## **East Bayfront Functional Servicing Report**

**Updated March 2009**

## Responses to Comments

### Letter from City of Toronto (April 7, 2008)

Figure 5-5: Stormwater Management Facility Concept - Option B

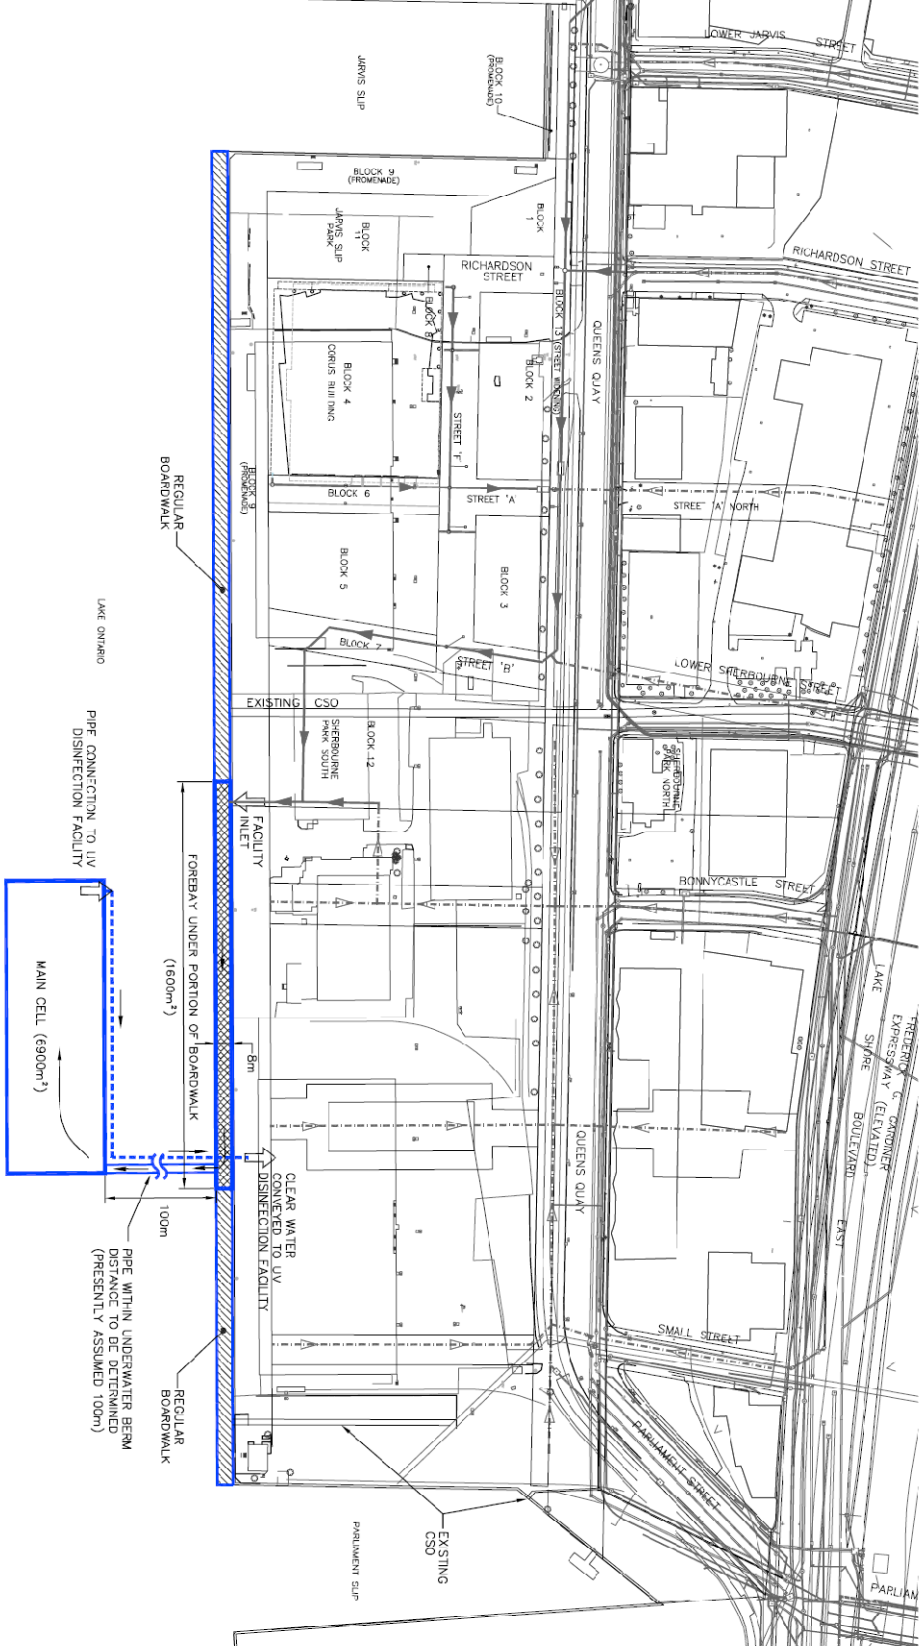
- iv. Include shipping lane that Port Authority uses as a reserve in front of East Bayfront to get to Redpath Sugar, and comment on how Option B (Figure 5.4) would interfere with that reserve.*

**Figure 5-3** within this updated report illustrates the shipping lane requirement of Redpath Sugar. This requirement does present a constraint to Options B and C presented in the December 2007 FSR, and was a factor considered in identification of the preferred facility configuration described in **Section 5**.

FIGURE 7-2

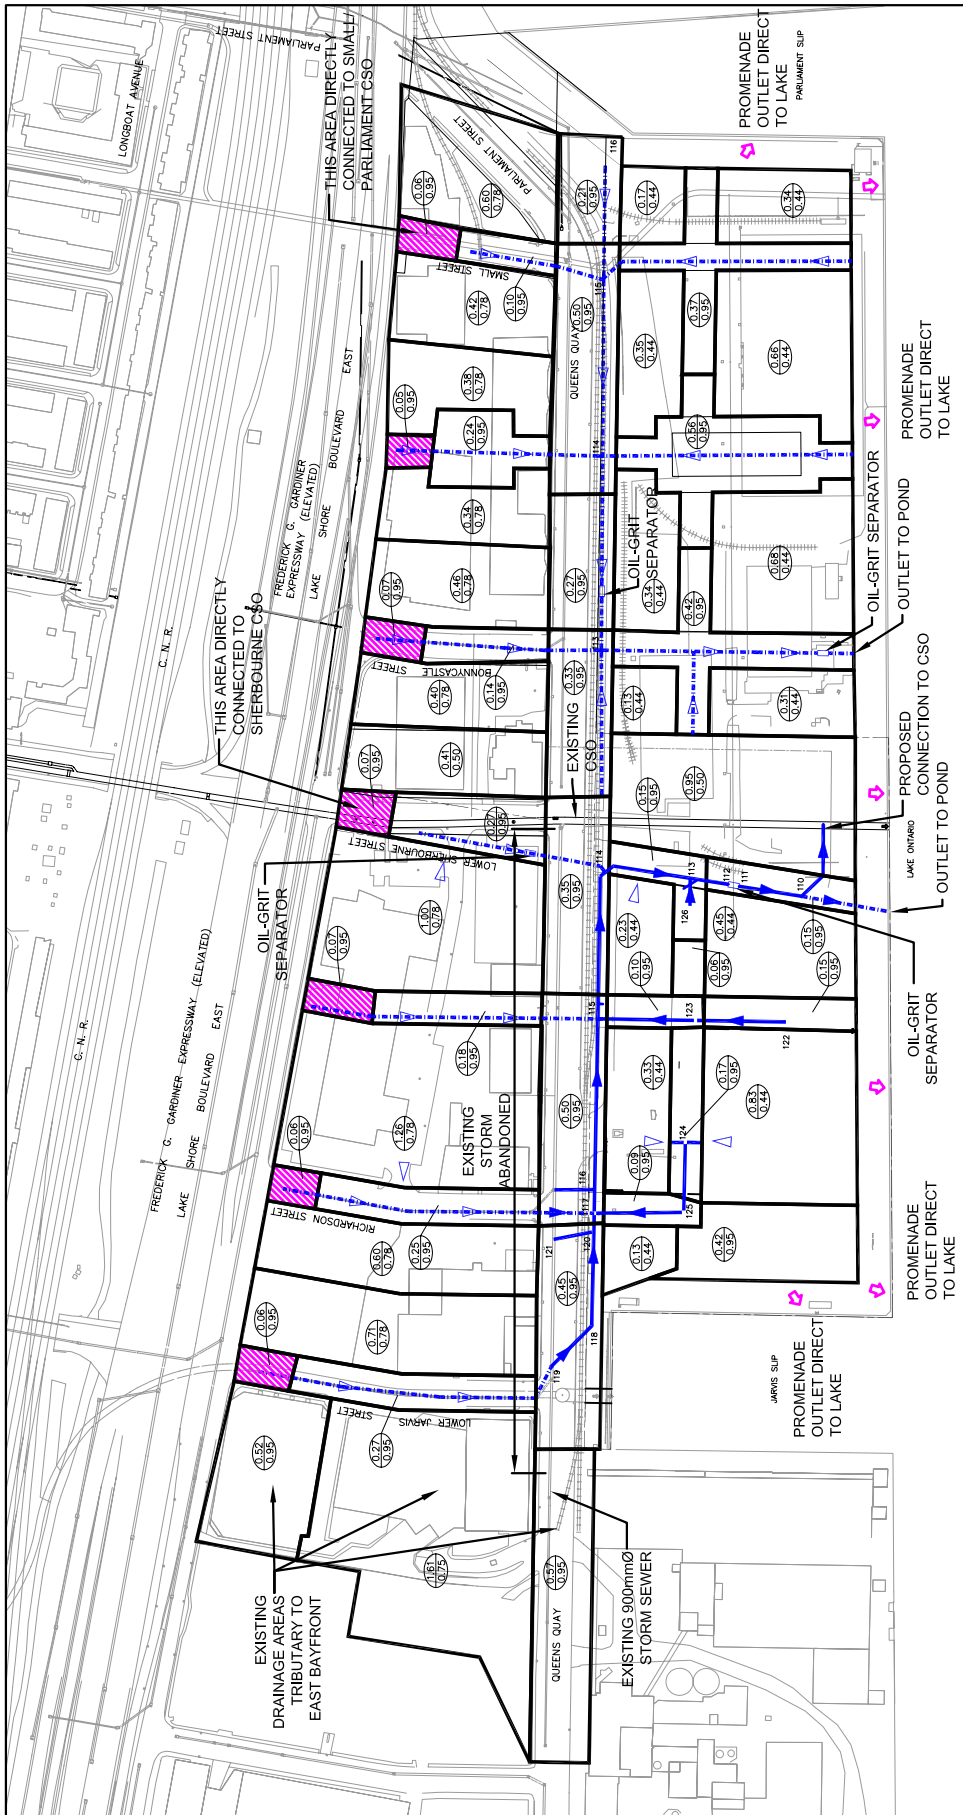
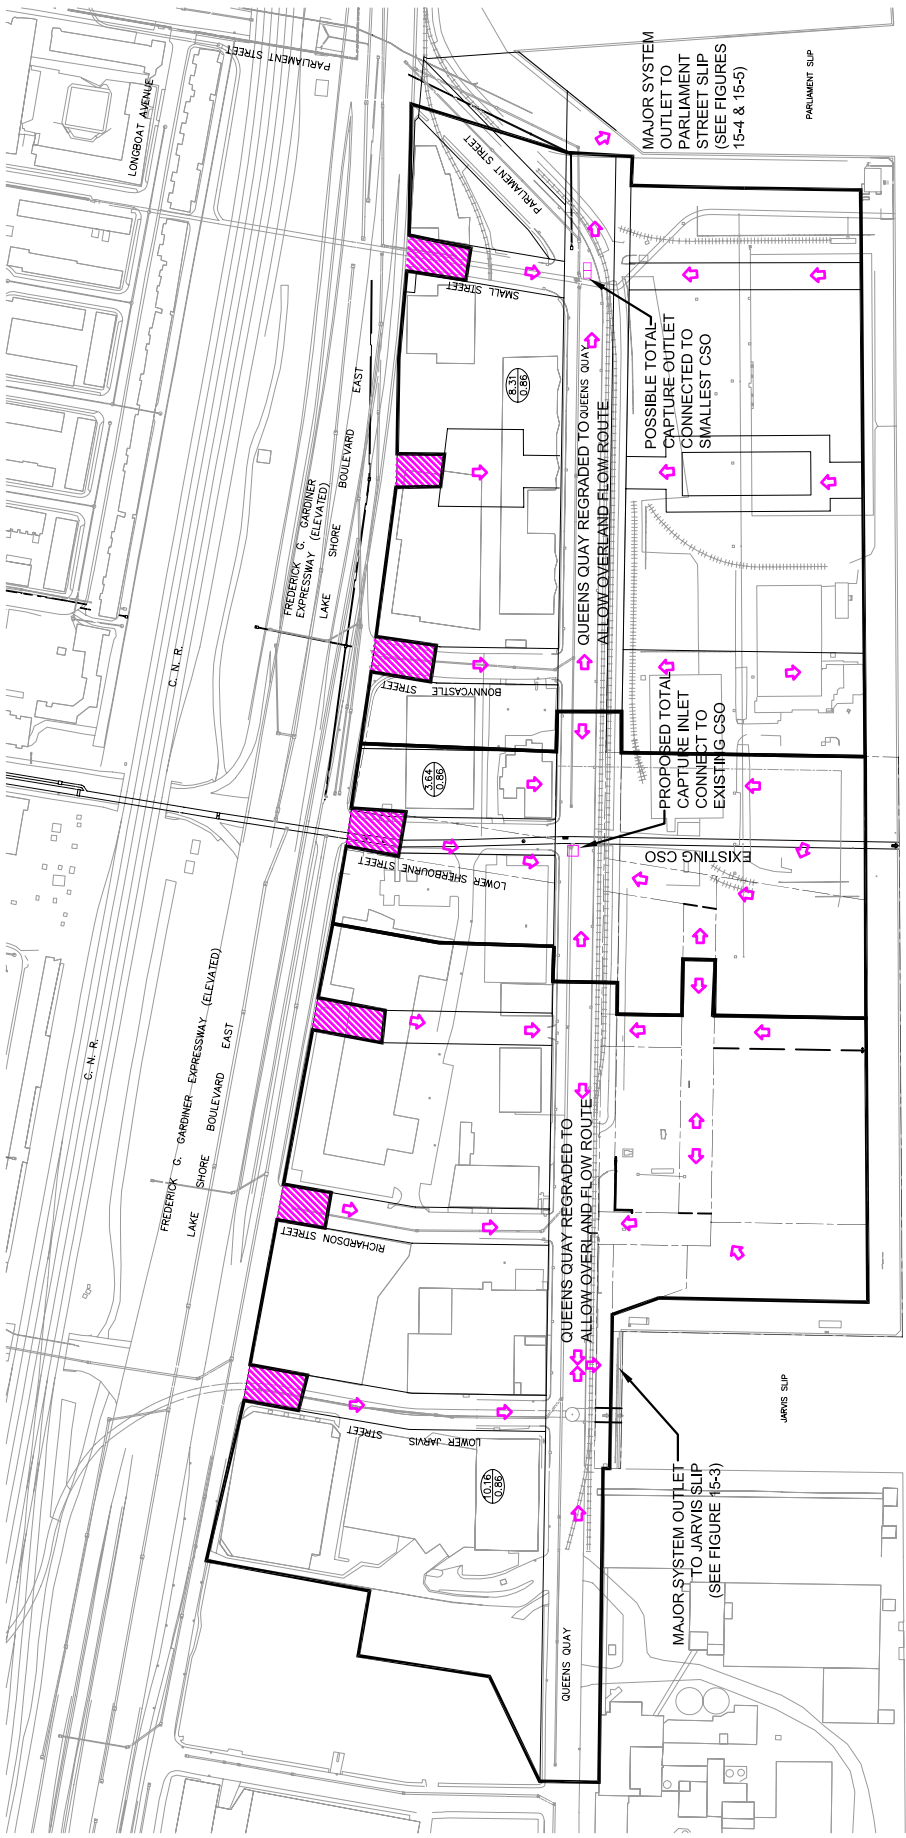
- a. *Figure 7.2 and 7.3, Section 15: Flooding is anticipated under major rainfall events along Lakeshore. Confirm that proposed grading within EBF will not make flooding worse. A proposed full topographic survey should include Lakeshore to confirm its profile and overland flood routing. Reconfirm any opportunities to alleviate flooding on Lakeshore by taking major flows through EBF or otherwise, without adversely affecting existing CSOs or the proposed lake pond, under interim and ultimate conditions.*
